TC1796

32-Bit Single-Chip Microcontroller

TC1796 Documentation Addendum

Revision History: V1.2 2007-04

Figure 5-11 GPTA0/GPTA1/LTCA2 Input IN1 Control

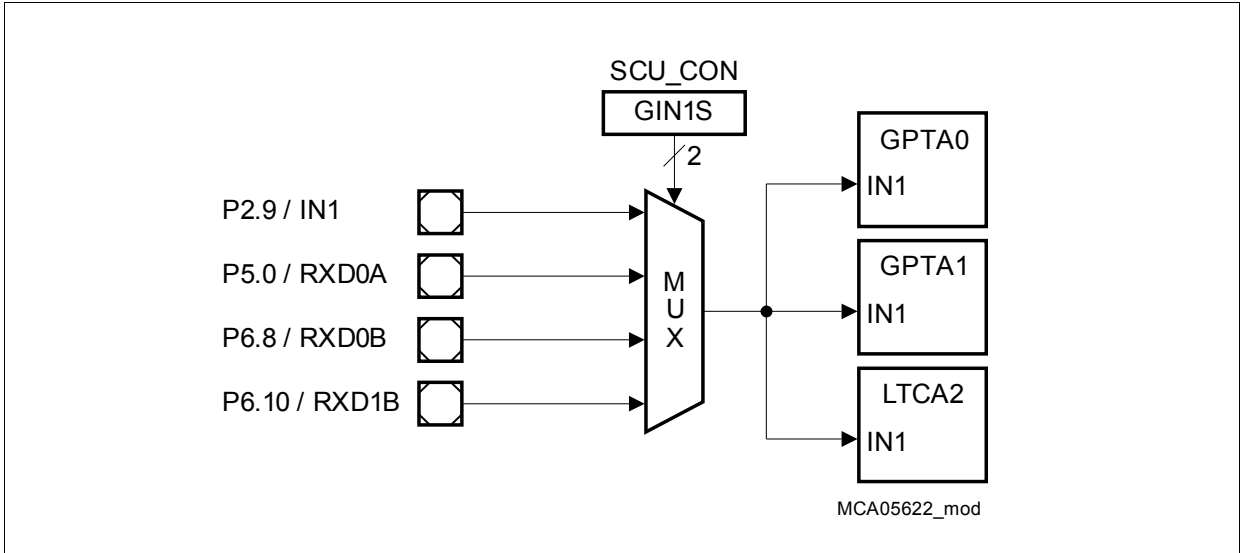
The first sentence on the top “In the TC1796, ...” must be replaced by the following sentence: “In the TC1796, the input lines IN1 of the **GPTA0**, **GPTA1**, and **LTCA2** modules can be used to measure the baud rate of an ASC0 or ASC1 receiver input signal.” Additionally, Figure 5-11 must be corrected.

Figure 6-12 Basic FPI Bus Transactions

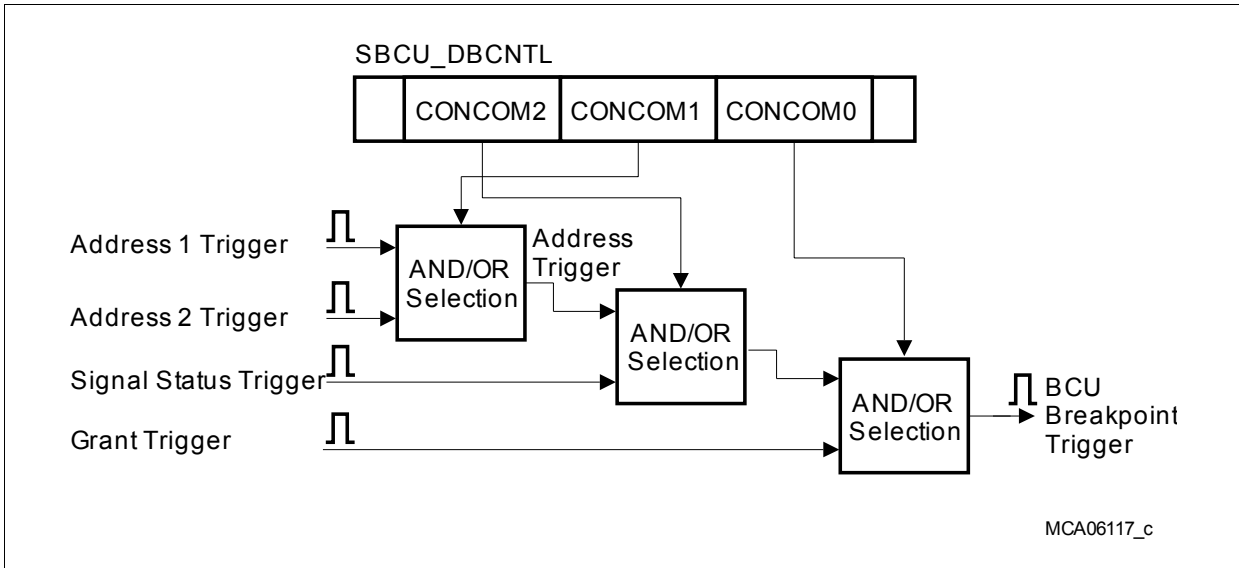
Figure 6-12 must be replaced with the below figure:

Figure 11-14 Counter Operation for BCOPY Instruction

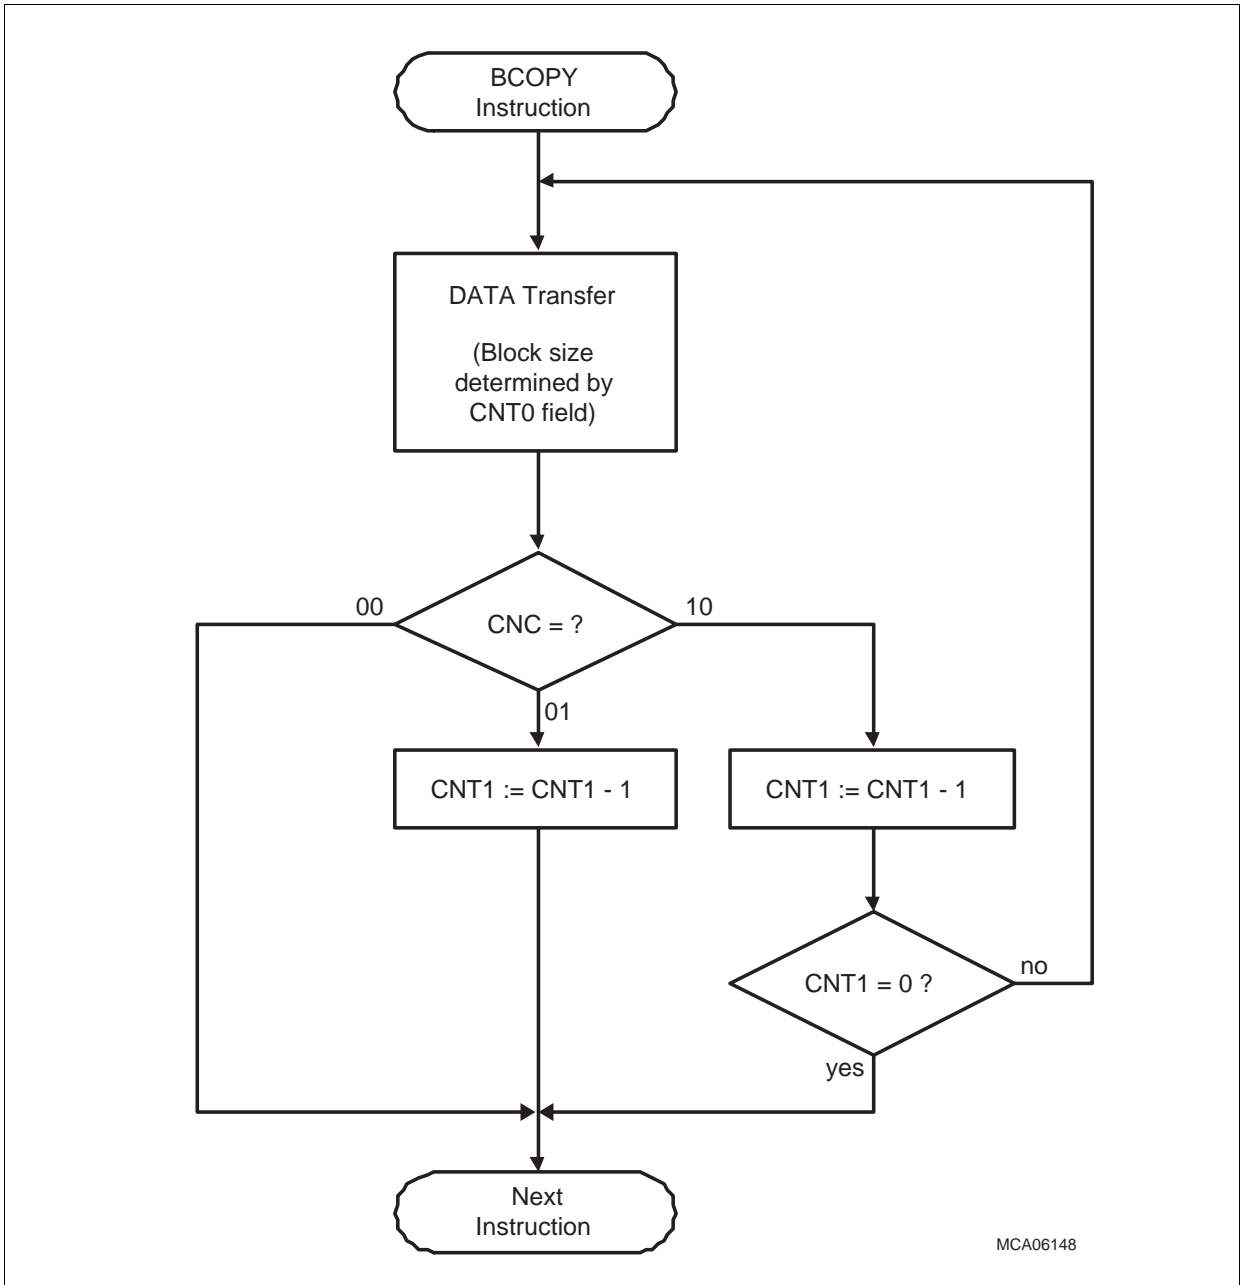
Figure 11-14 must be replaced by the following figure (block "DATA Transfer" has been changed):

Figure 12-5 Channel Request Control

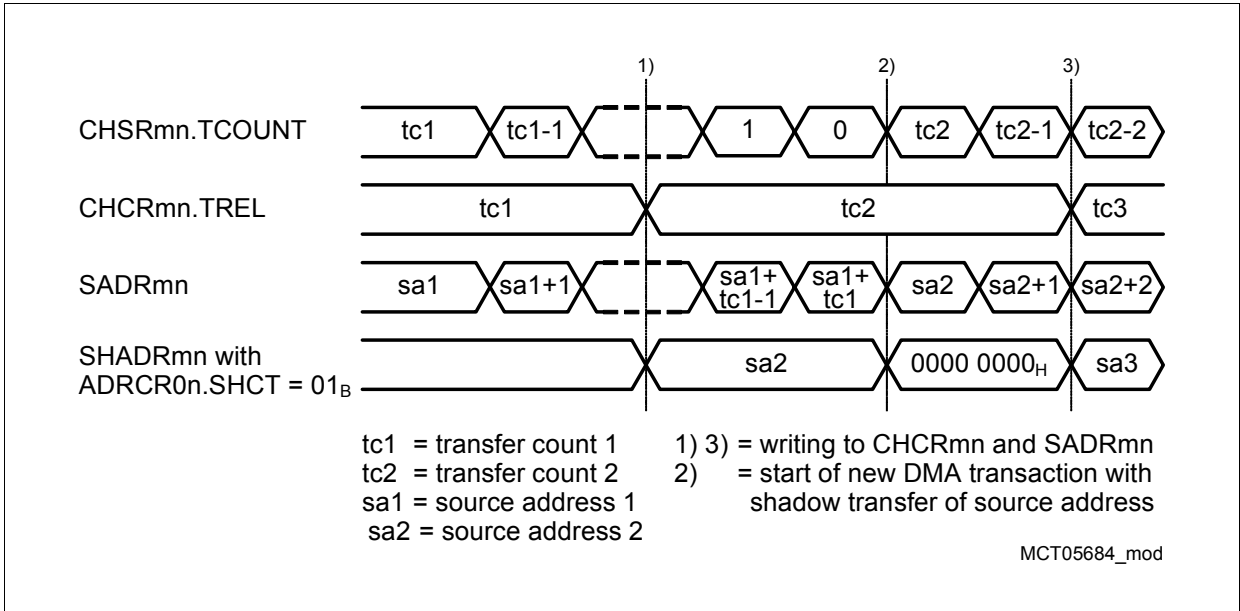
The wordings “SHADR0n with CHCR0n.SHCT = 01_B” on the left of the first waveform from the bottom of Figure 12-5 must be replaced with “SHADR0n with ADRCR0n.SHCT = 01_B”.

Figure 12-6 Channel Request Control

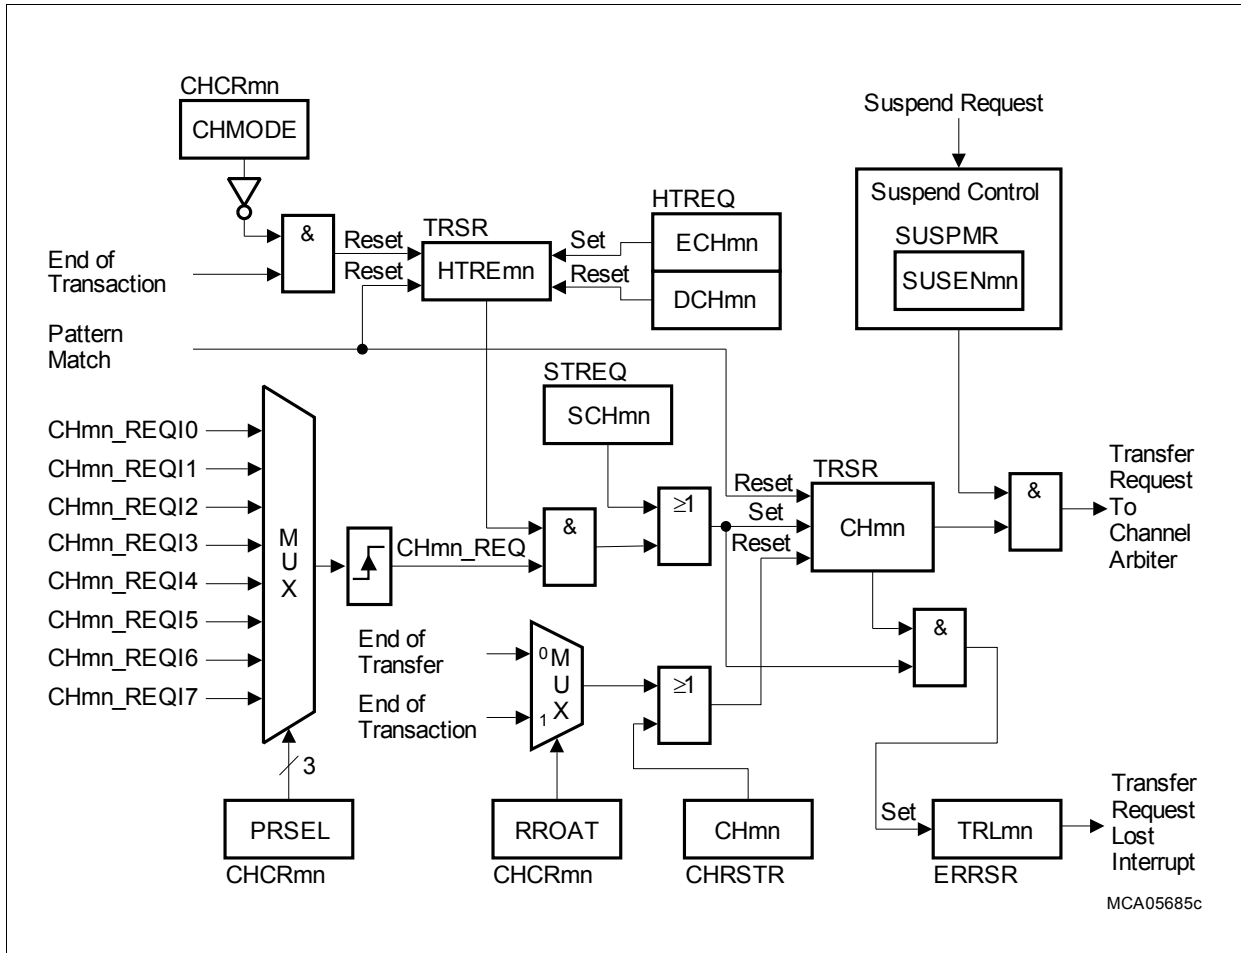
Figure 12-6 must be updated caused by the changes on pages 12-34 and 12-49.

Figure 12-18 Transaction Lost Interrupt

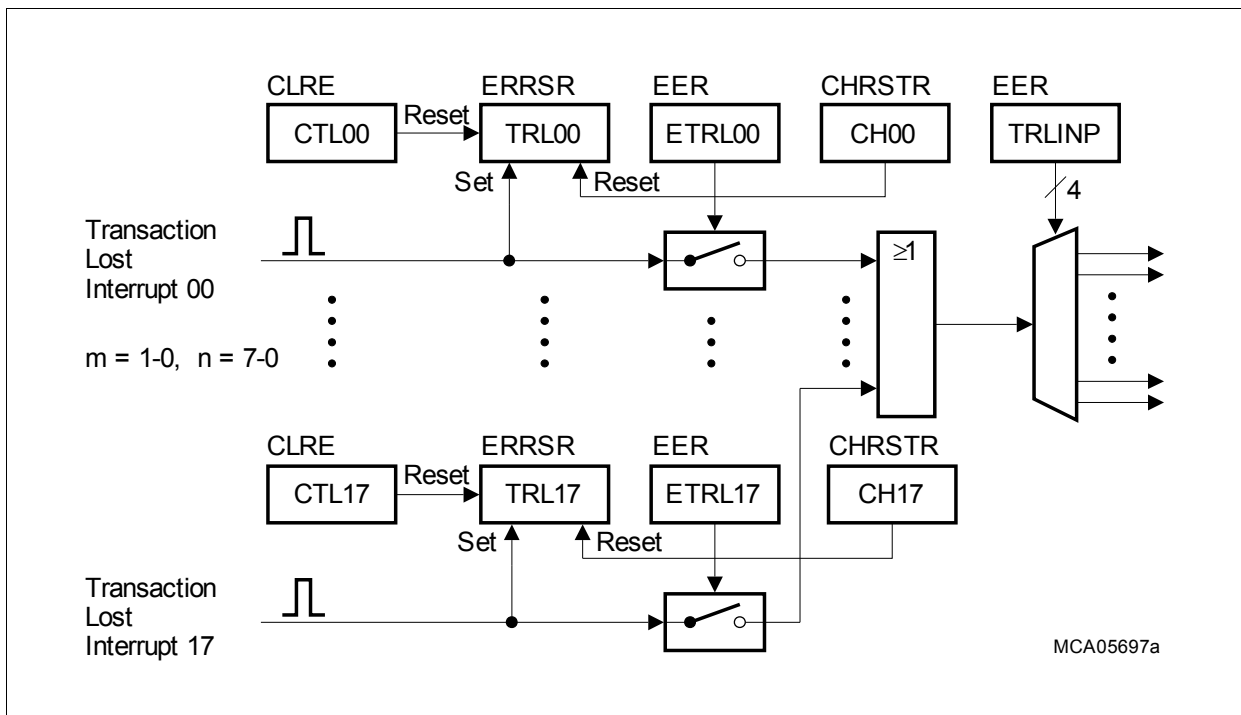
In Section 12.1.8.2, the register name EERSR must be replaced by ERRSR in the third sentence of the first paragraph, first sentence of the second paragraph and within Figure 11-18. The corresponding text must be replaced by :

Figure 12-18 must be replaced by:

“If such a transaction request lost condition occurs, bit ERRSR.TRLmn is set.” and “A transaction request lost condition of DMA channel mn is indicated by status flag ERRSR.TRLmn, which can be reset by setting bit CLRE.CTLmn or CHRSTR.CHmn.”

Figure 12-19 Move Engine Interrupts

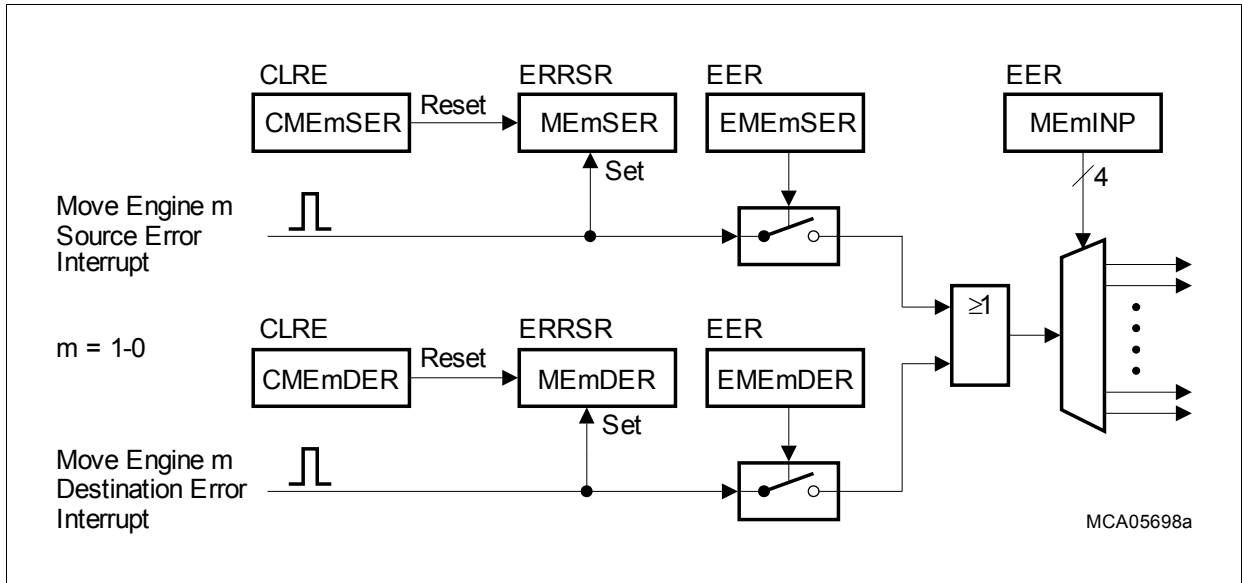
In Section 12.1.8.3, the register name EERSR must be replaced by ERRSR in the first sentence of the third paragraph and within Figure 11-19. The corresponding text must be replaced by :

Figure 12-19 must be replaced by:

“A source error of Move Engine m is indicated by the status flag ERRSR.MEmSER.”

Figure 14-5 NMI Trap Handler Routine for Parity Error Handling

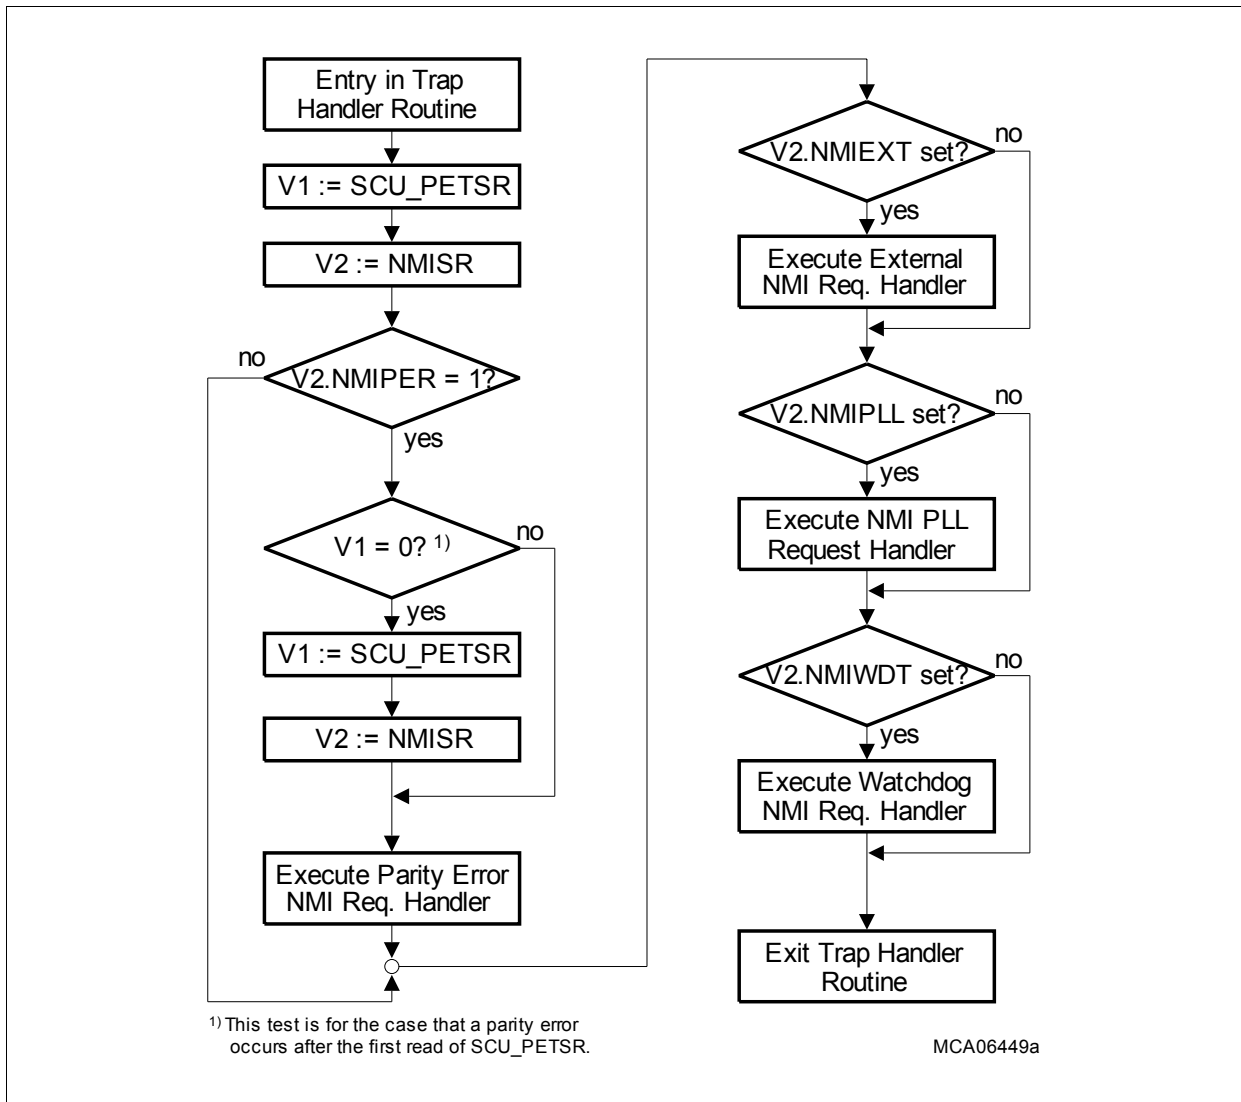
Figure 14-5 must be updated with the following corrected drawing.

Figure 24-91 Connections of GPTA with On-Chip Modules

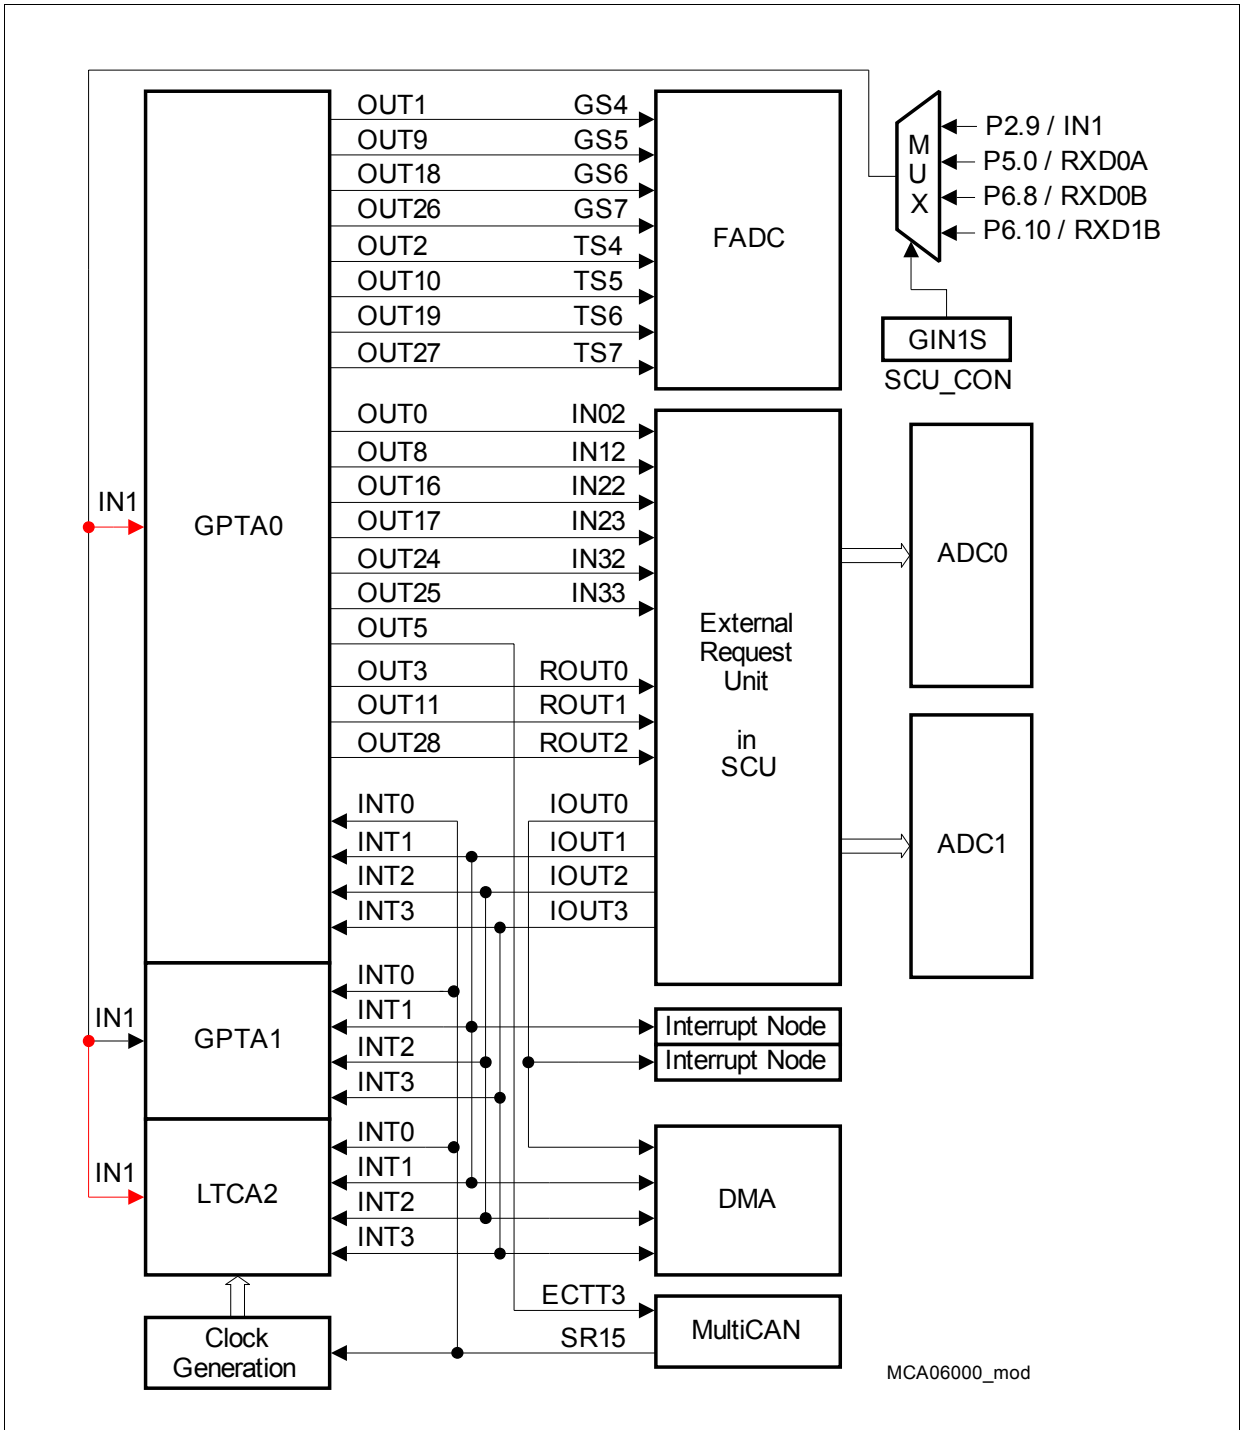
Figure 24-91 must be replaced by the following figure: The red marked parts indicate the changes.
